Access Compliance Report

Public Rights-of-Way

(Curb Ramps)

Intersection ID: 47281	Main Street: SAVANNAH_HILLS_DR	Cross Street: CANDLEWOOD_RIDGE_LN	Location: SE
ADA ID: A1D372B77FD4	Ramp Type: PerpDiag	Initial Pass/Fail: Fail	Overall Compliance: No
Severity Score: 13.75			
Codes/Mitigation Info/Possible Solution		Field Measurements/Component Compliance

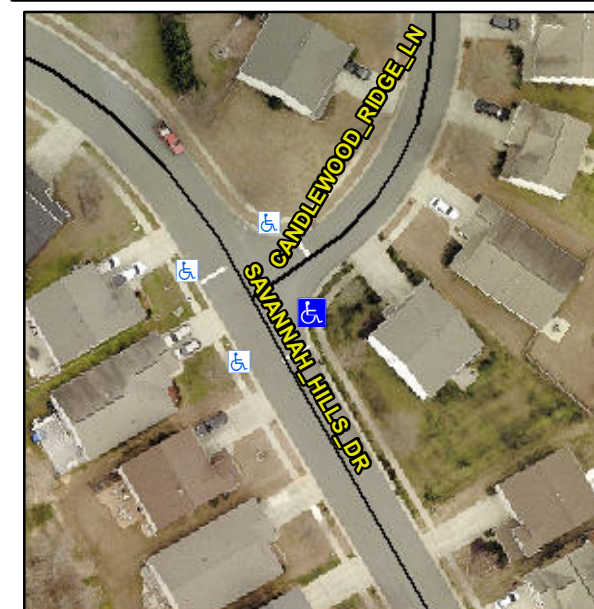
Remove & Replace Curb Ramp With Two New Directional Ramps or Equivalent.

R304.2.2, R304.5.3
